**Historic Landmark Commission  
March 26, 2012  
Certificate of Appropriateness  
LHD-2012-0002  
4313 Speedway  
Hyde Park Local Historic District**

Demolish existing 2<sup>nd</sup> story rear addition and construct a new two-story rear addition.

# NESTOR-ZULLO RESIDENCE

A2.2

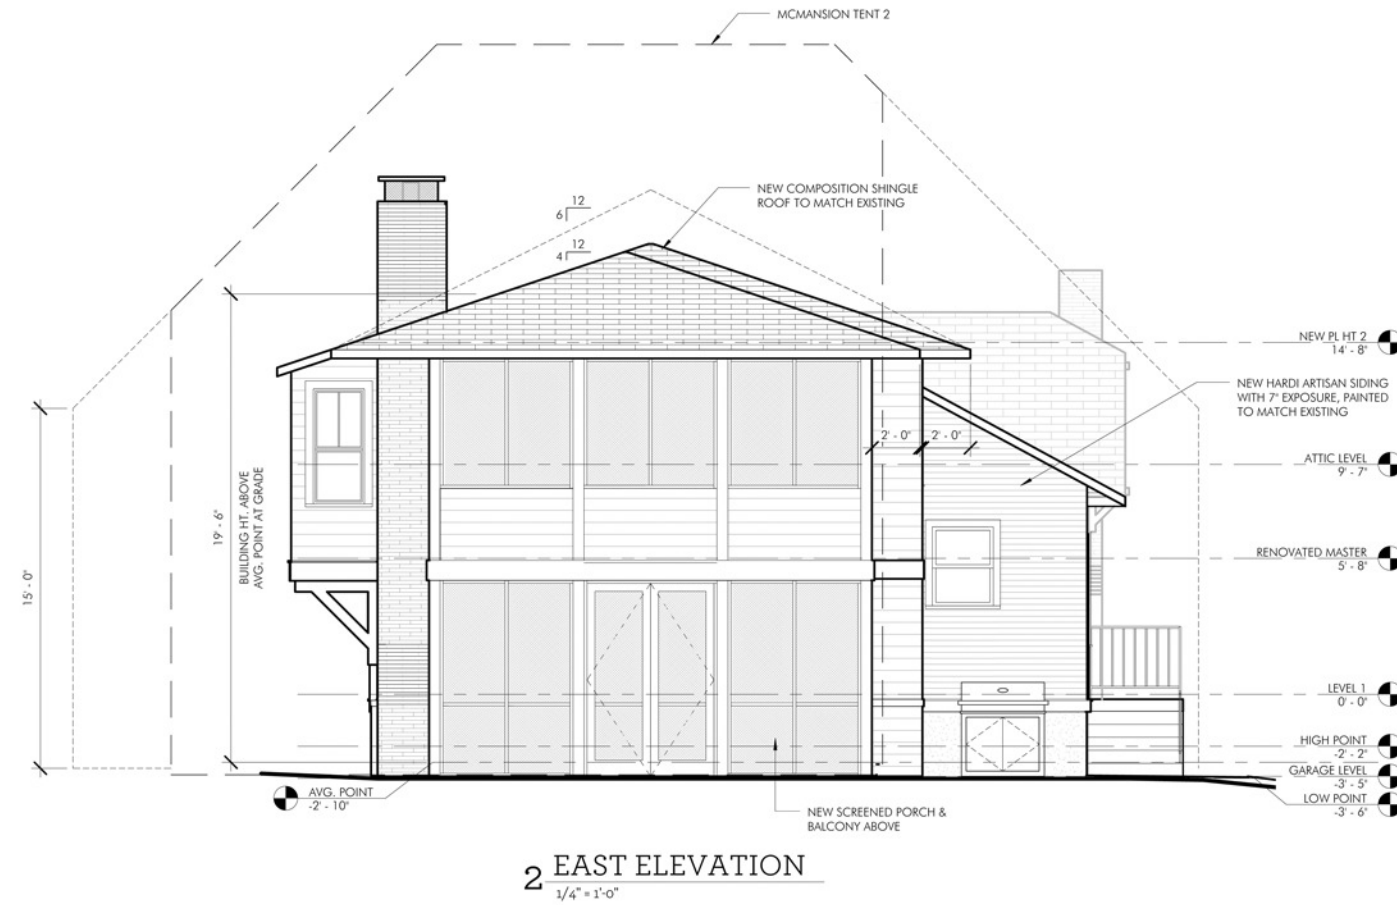
The project was reviewed at a Certificate of Appropriateness Review Committee meeting. The Committee preferred that the 2-story bay on the south elevation be eliminated, and that the configuration of the side door, flanked by two windows, be maintained.

Staff recommends approving the project as proposed by the applicant.
